MISO's Responses to Stakeholder Questions

Original Posting October 5, 2021

Reposted December 17, 2021

Fall Zonal Estimated Surplus/shortfall to meet Seasonal PRMR (GW)

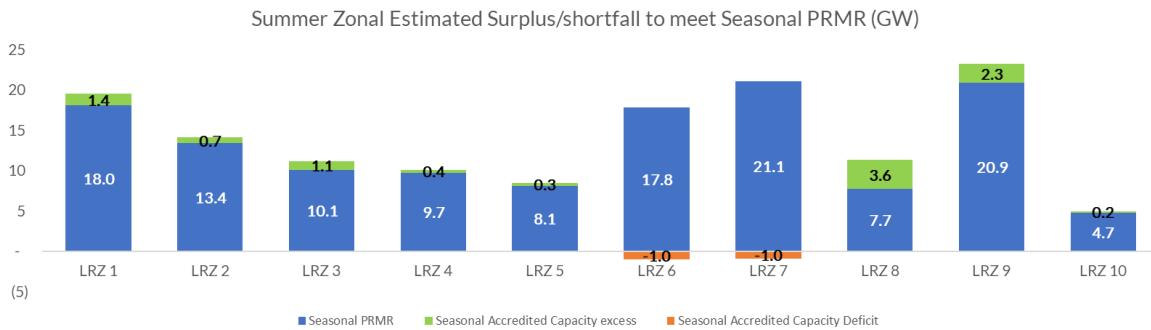
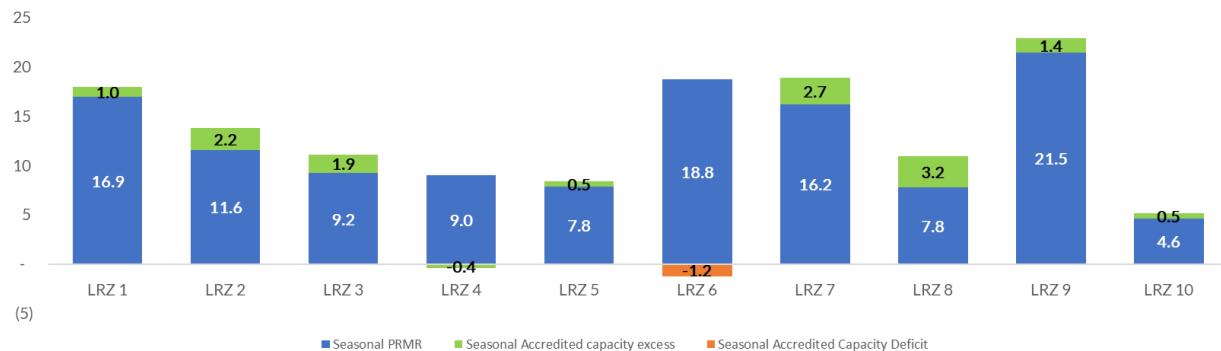
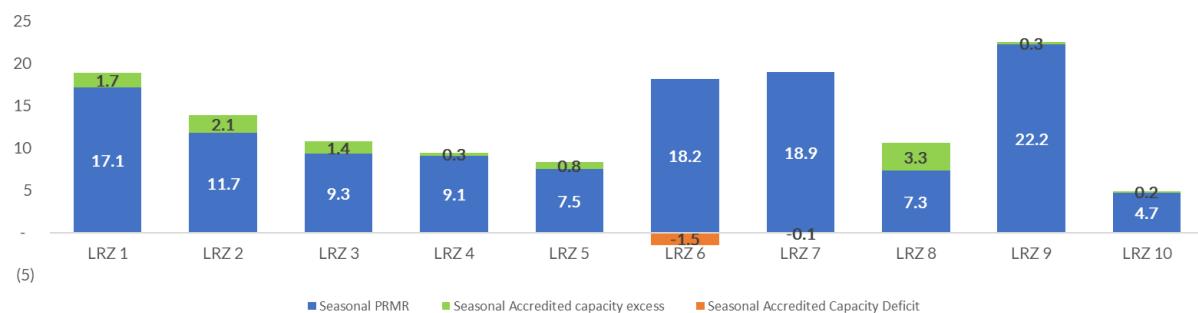
Zonal net positions vary across seasons driven by seasonality of Capacity Import Limits (CIL) and resource availability

Based on preliminary analysis, all zones are observed to have sufficient capacity to cover seasonal LCRs with the exception of Zone 10 in winter driven by lower SAC and significant reduction in its winter CIL

MISO Response: MISO has revised its RA construct proposal since July 7, 2021 and adopted the recent IMM's proposal of a UCAP to SAC conversion ratio to convert individual thermal resource SAC values back to UCAP terms. The system wide and zonal impact analysis results are refreshed and included in the materials for the November 3, 2021 RASC meeting, reflecting the revised RA proposal. The zonal impact analysis results at the PRMR level are illustrated below:

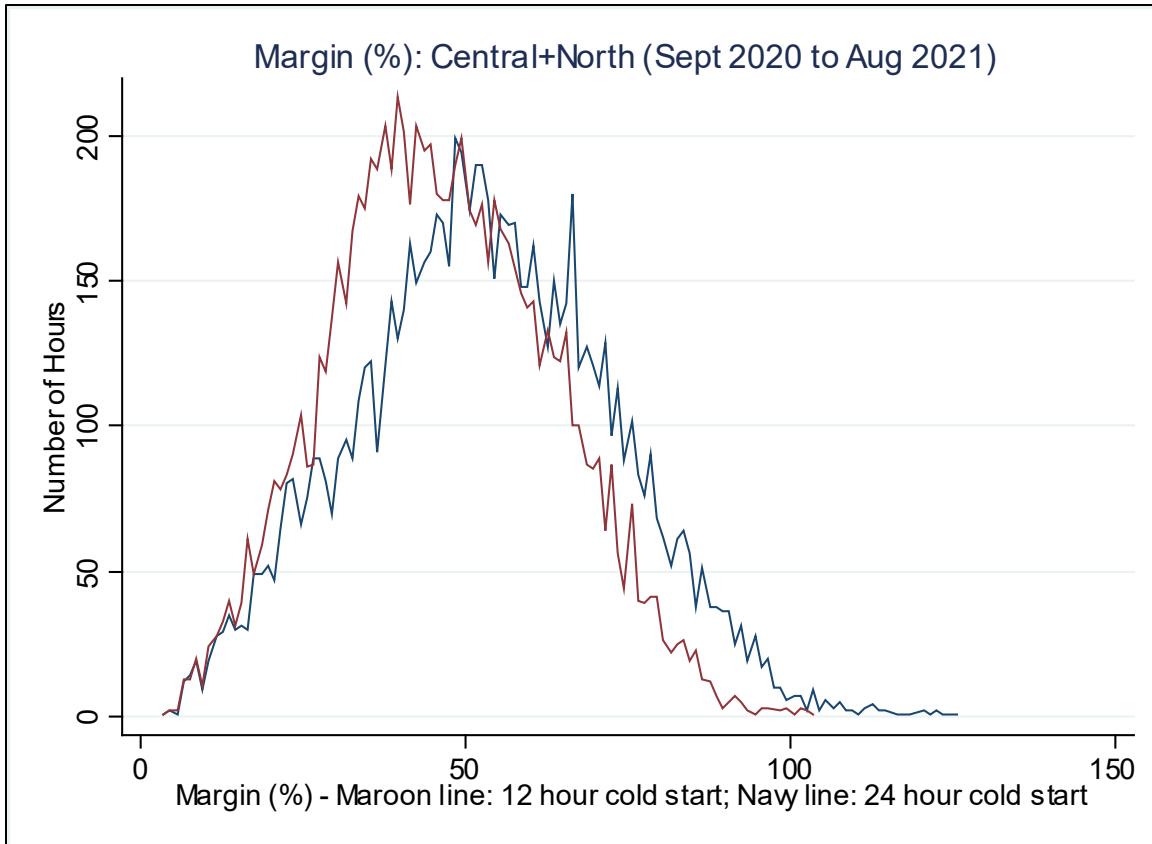
a. Please provide the analysis and basis for using 25% operating reserve as the criteria for defining an RA hour.

MISO Response: MISO has evaluated the distribution of operating margin as illustrated in Figure 1 and Figure 2 of the Conceptual Design document presented at the August 19, 2021 workshop. MISO found that the 25% threshold provides a good balance between having adequate number of RA hours and selecting the set of RA hours that are truly tight. Utilizing the 25% threshold also captures the vast majority of declared MaxGens but more are missed at lower thresholds due to uncertainty in RT operations. If using 20% threshold instead, too many RA hours in seasons other than summer would be excluded in multiple planning years, resulting in sample size of RA hours too small.
